**MaineHousing's UFAS Clarifications**  
(7/8/13)

**Figure 404.2.4.3**  
**Maneuvering Clearances at Recessed Doors and Gates**

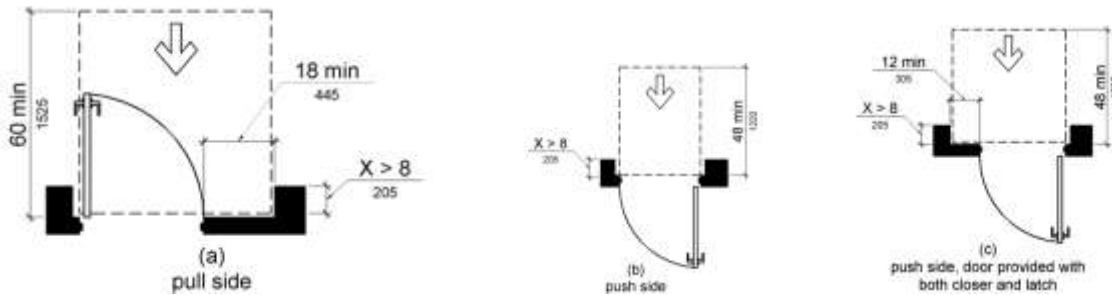
MaineHousing question: We have a situation with an apartment entry door with spring loaded hinges (which act like a closer) to an accessible unit (right-hand picture below) and we interpret that we need 12" minimum clear on the latch side/push side of the door (Fig. 25 (a)). Is there a maximum thickness of the wall in which the door sits? In our case we have a 24" thick wall (usually only 5" plus/minus) within the 12" space and the door is mounted to the inside of the 24." Other codes suggest that the maximum thickness is 8" from the door trim to any obstruction within the 12" clear space required, but I don't see anything specific in UFAS.

HUD answer: *“UFAS has no thickness requirements.”*

The HUD response is not very helpful in providing guidance; in situations like this it is generally advisable to take the next step of researching what the 2010 ADA standards have to offer as meeting Fair Housing requirements is necessary as well. In this instance, Figure 404.2.4.3 provides a great reference and guidance in analyzing such situations and, as such, it is prudent for MaineHousing to assure compliance using these standards.
